VILLAGE OF PALATINE
VILLAGE HALL - COUNCIL CHAMBERS
200 E. WOOD STREET
PALATINE, IL 60067-5339 – (847) 359-9050
<http://www.palatine.il.us>

MINUTES

AUGUST 3, 2020

1. Consider a Motion Approving the Final Fence and Screening Plan Along Hicks Road for the Ayreshire Subdivision (Northwest Corner of Hicks Road & Garden Avenue) - **Approved by Voice Vote** (Council District: Three)

HICKS ROAD LANDSCAPE PLAN

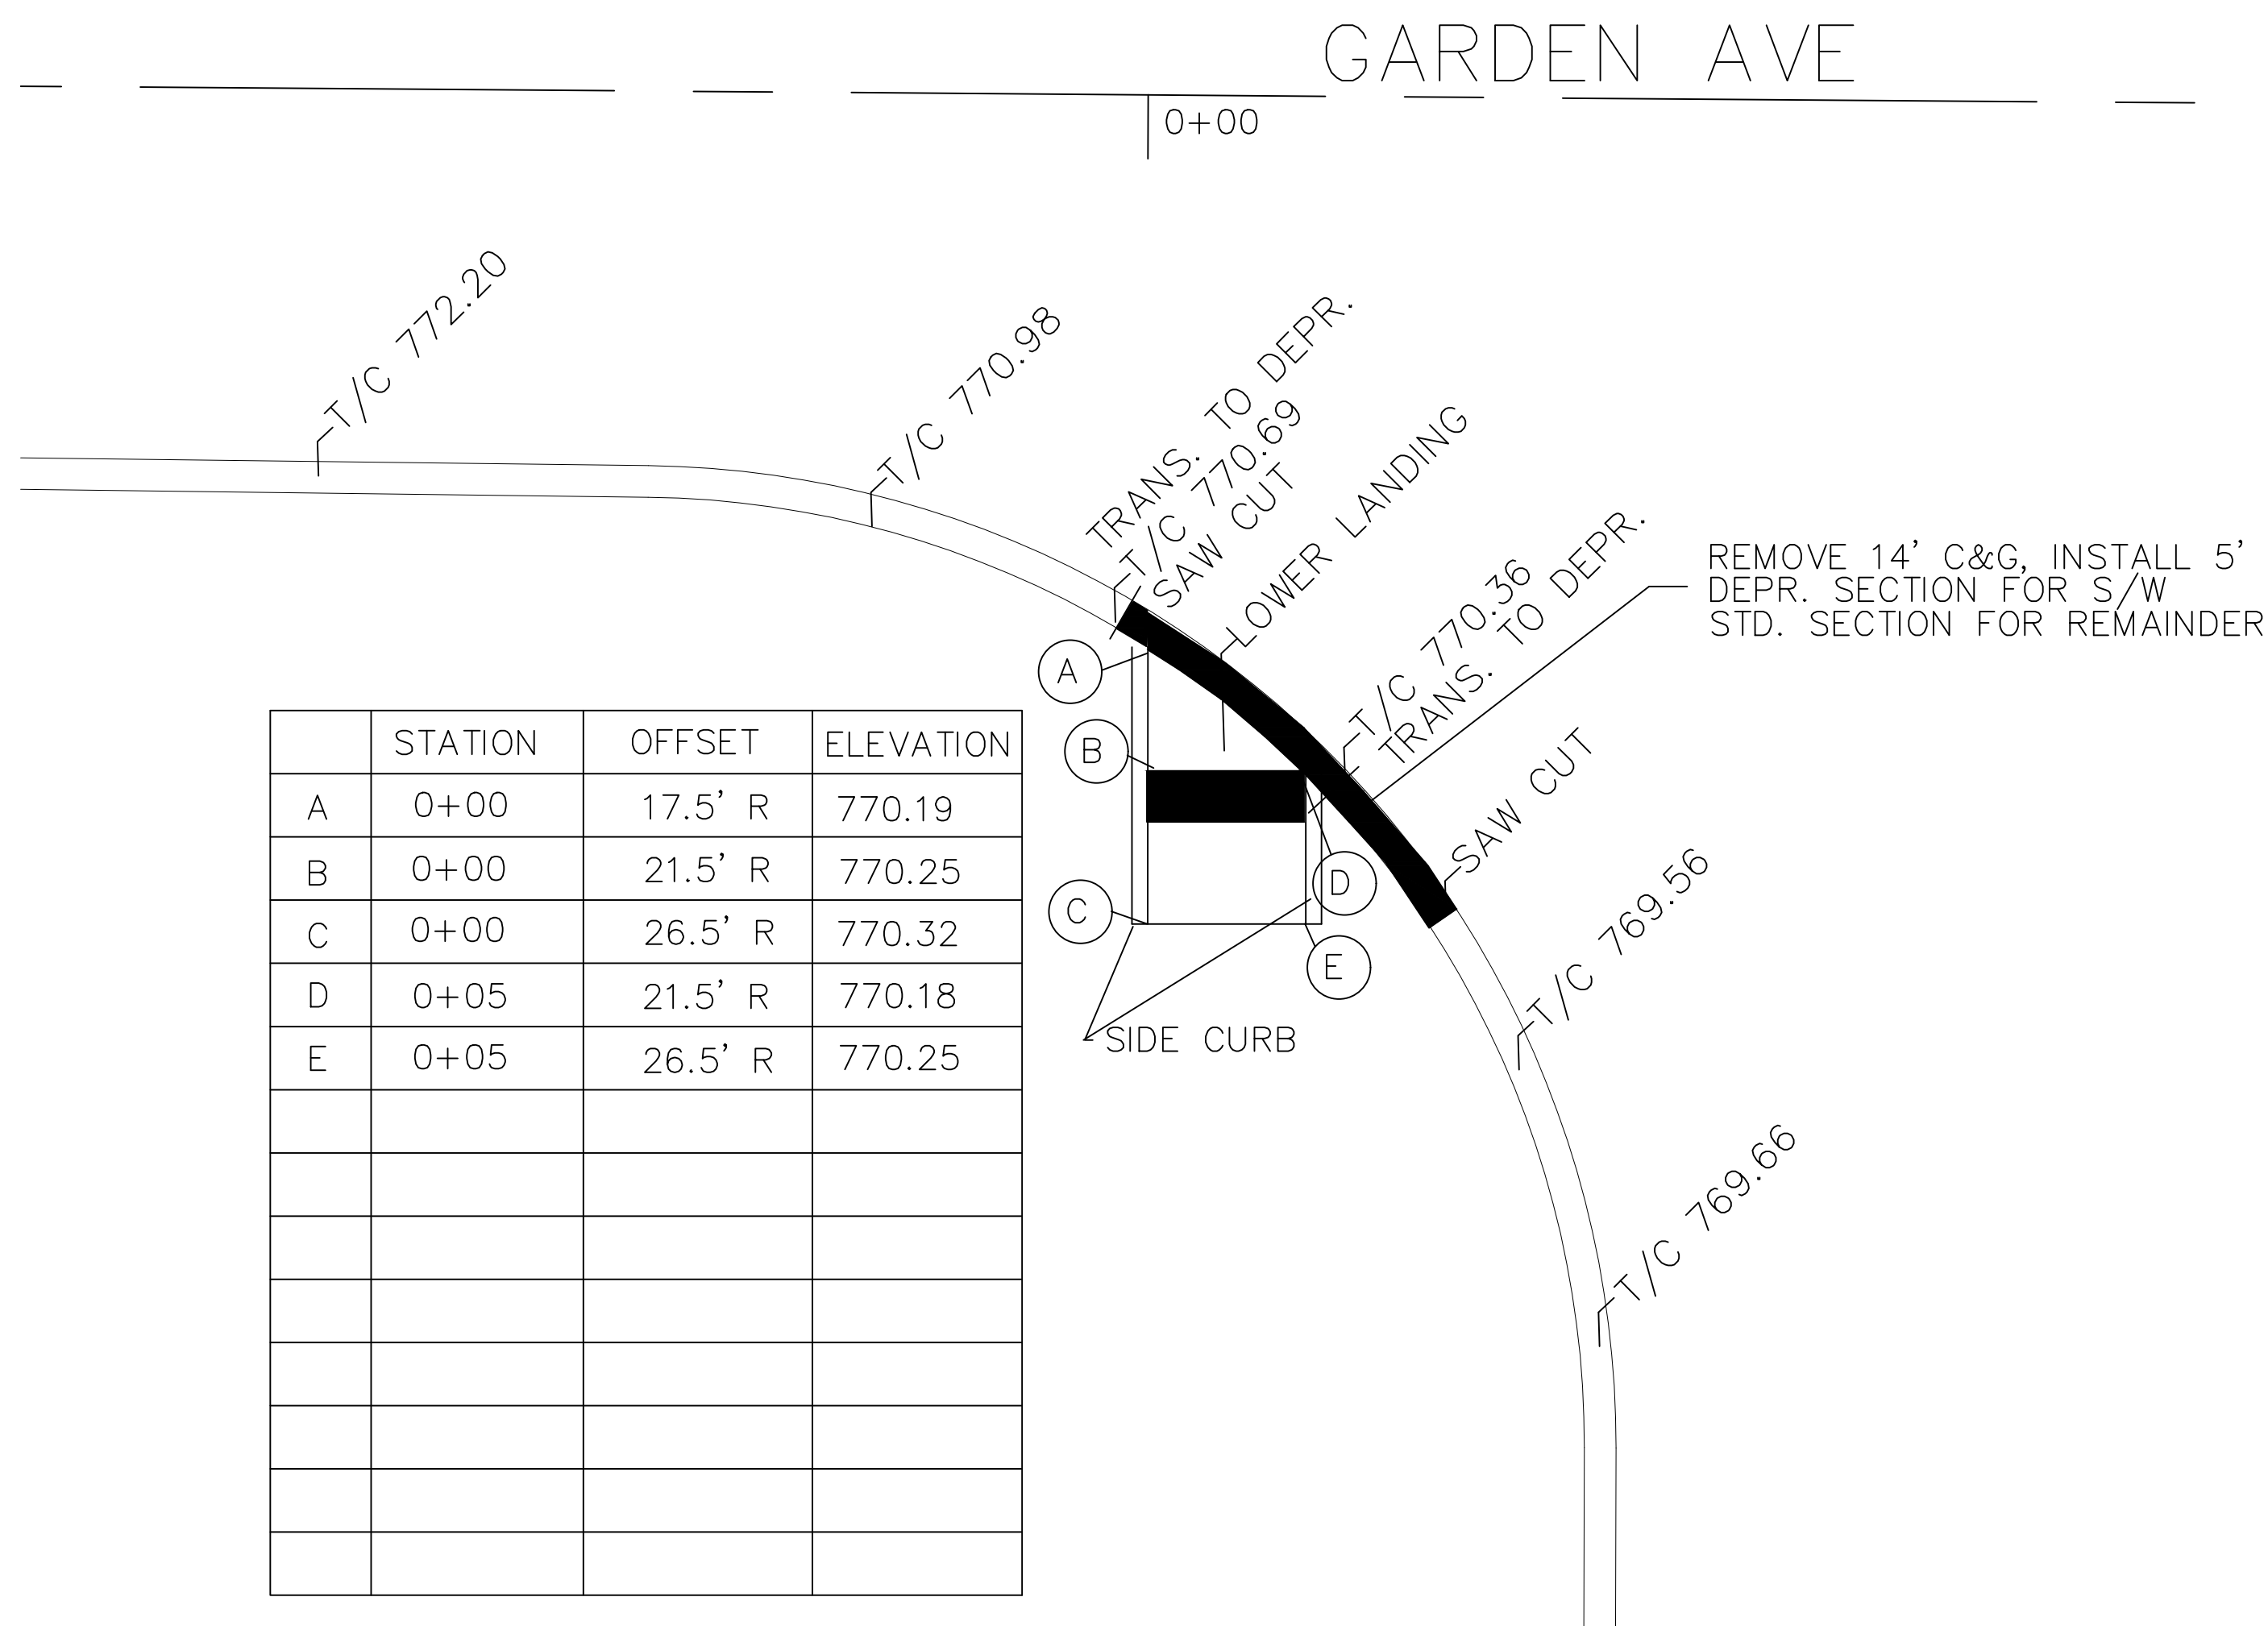
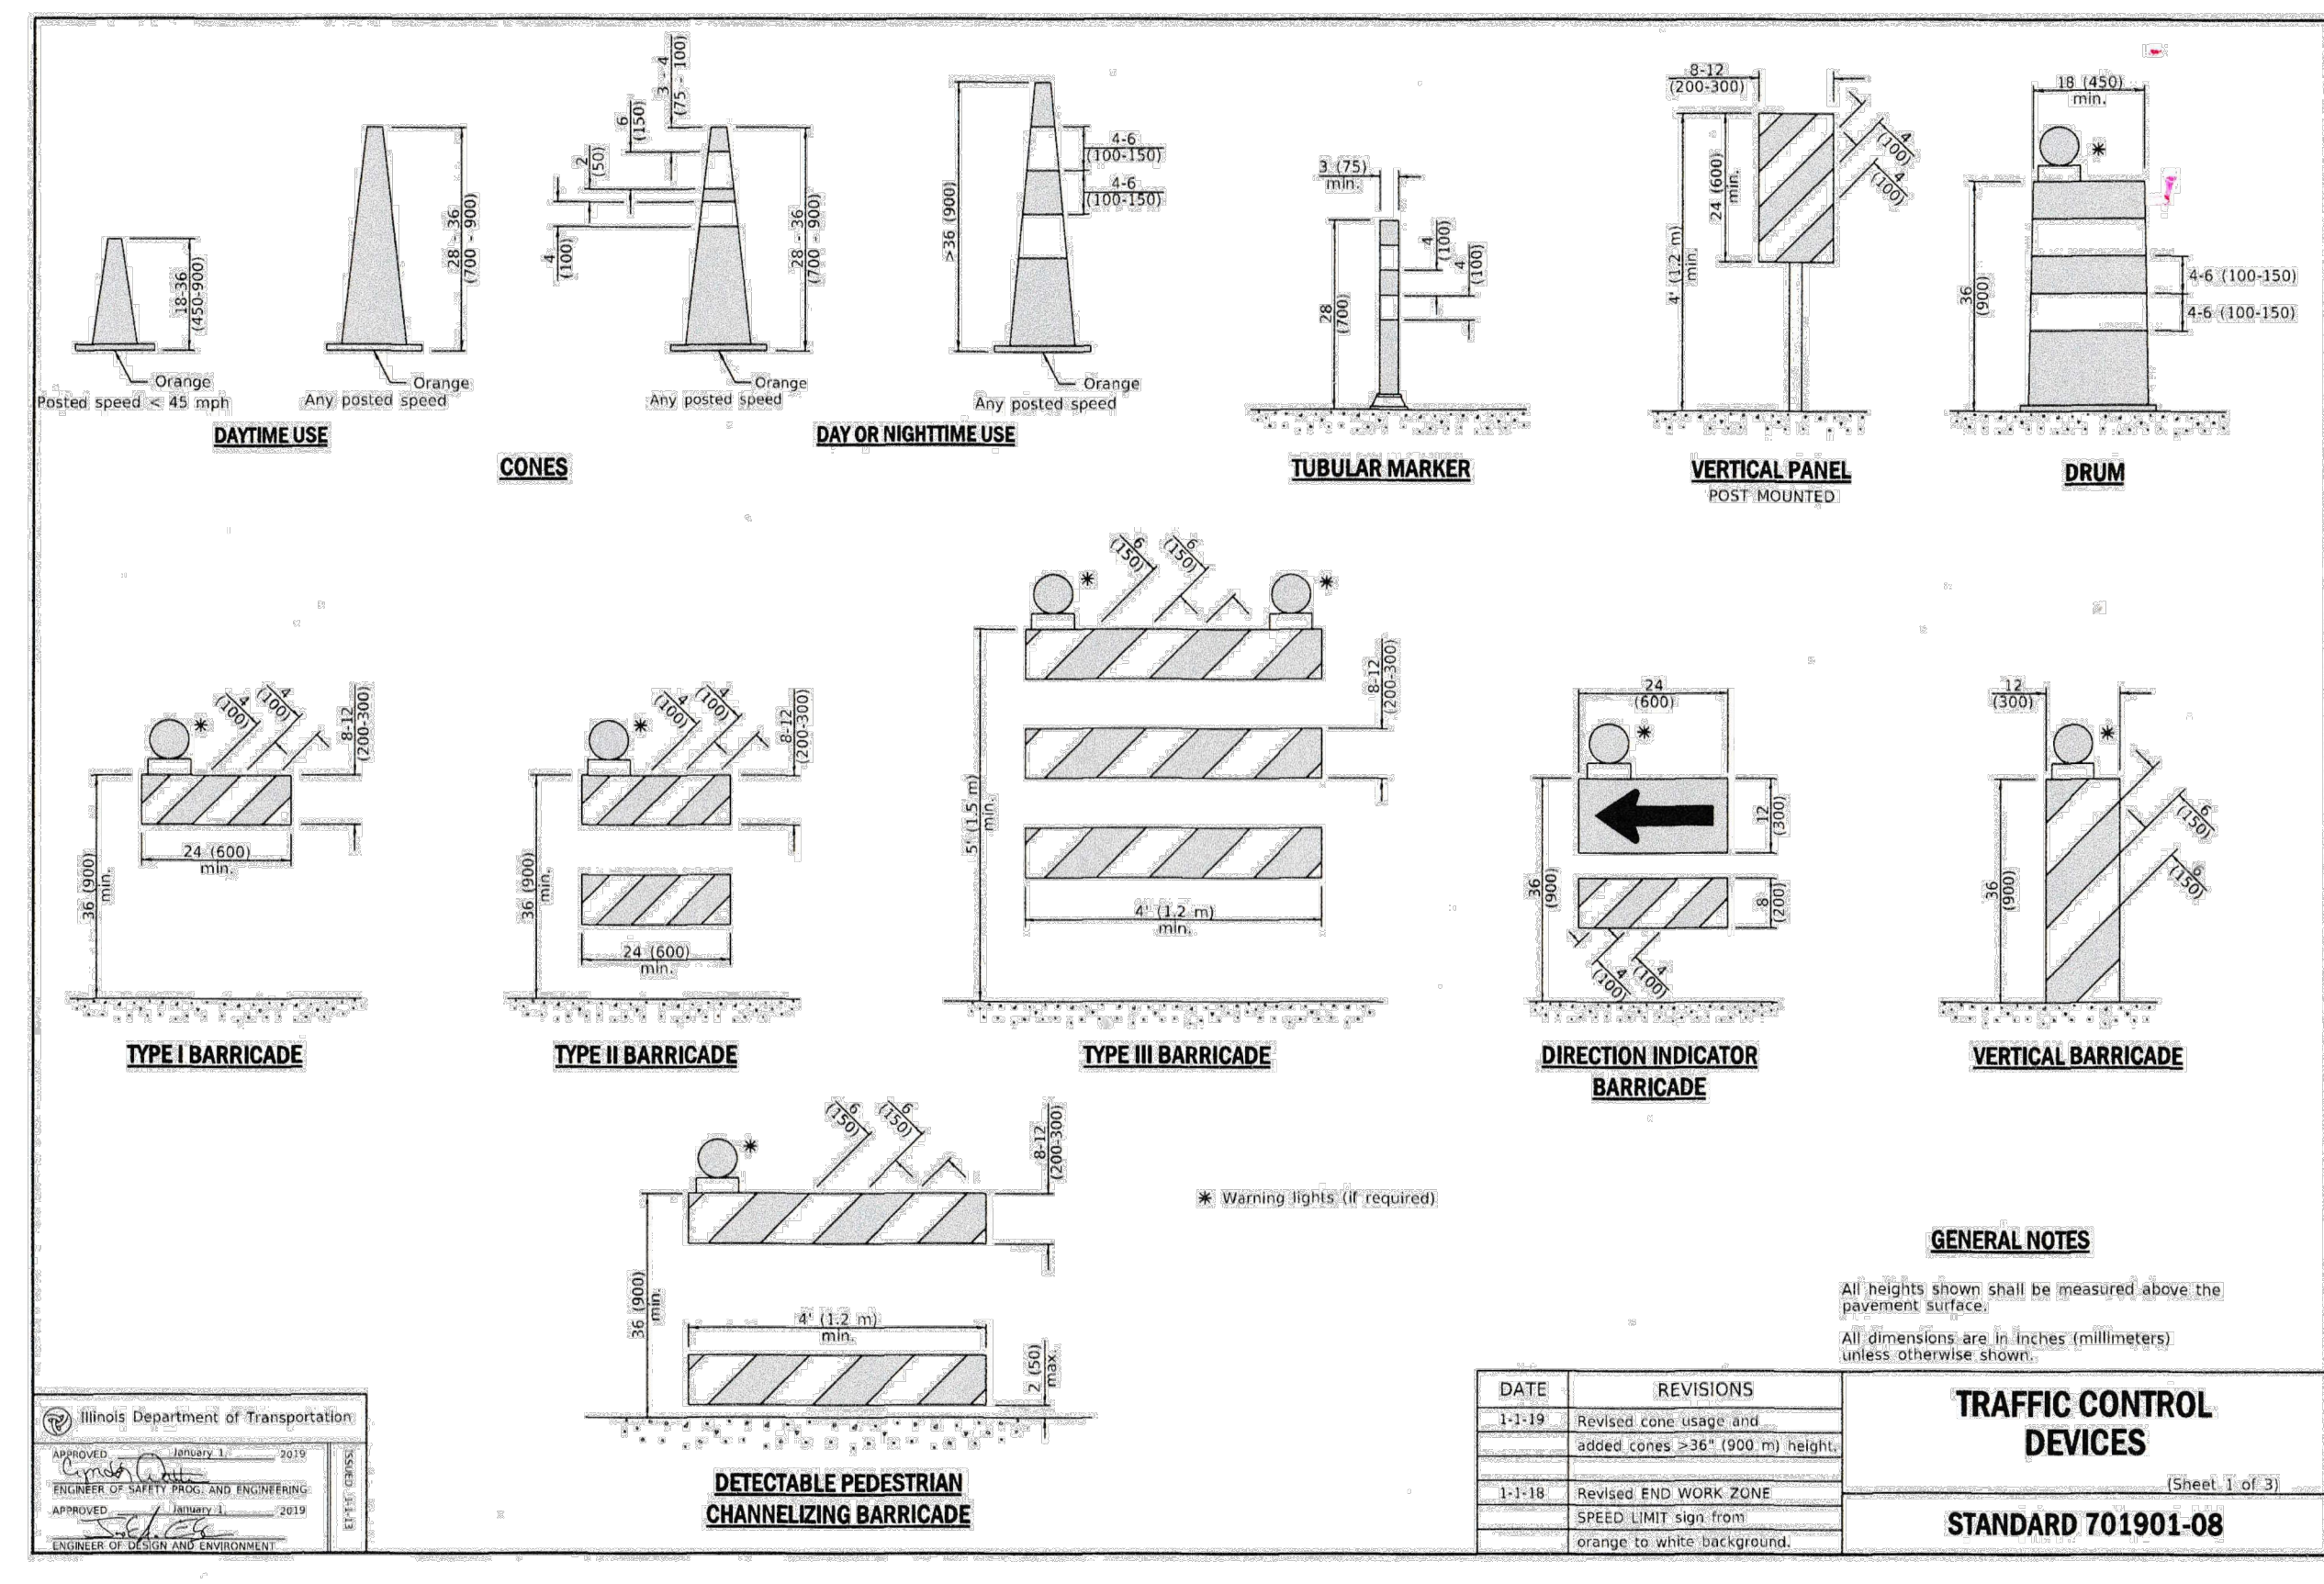
1. The plan should be amended to include plantings on the Hicks Road side of the 6' fence installations. The discussion at the meeting noted a desire by the majority to require plantings on the east side of the fencing sections.

2. There was also direction provided to include a few additional trees/evergreen within the Hicks Road planting. The Village Council also requested to better understand the anticipated mature heights of the shrubbery (redbud, quick fire, dogwood, etc.), as I believe that they wanted to anticipate what the final growth pattern and heights of the planting varieties, in conjunction with the 6 foot solid fence.

3. Tim attested to the IDOT requirement IDOT requirement to replace removed trees in the ROW. After discussing this and reviewing both the ENG plan (sheet 12), the landscaping plans should reflect the re-installation of the parkway trees, per IDOT. This will further answer the landscaping questions raised about screening along the fence sections. As part of that discussion, the Village Council also request that the elevation reflect the grade in the adjacent Hicks Road right-of-way in front of the fencing and landscaping.

Response: Plans have been revised as directed.

Response: Plans have been revised to include the addition of (3) evergreen trees and (1) shade tree (within the Hicks Road planting, off the NEC of building #4). Also, as mentioned below in the response to comment #3, (3) shade trees have been added in the Hicks Road ROW.

Response: Plans have been revised to reflect the incorporation of (3) replacement trees, (3) 3" caliper Sugar Maples (spaced 50' on center). The elevation has also been revised to reflect these (3) trees and the grade of the adjacent Hicks Road right-of-way.
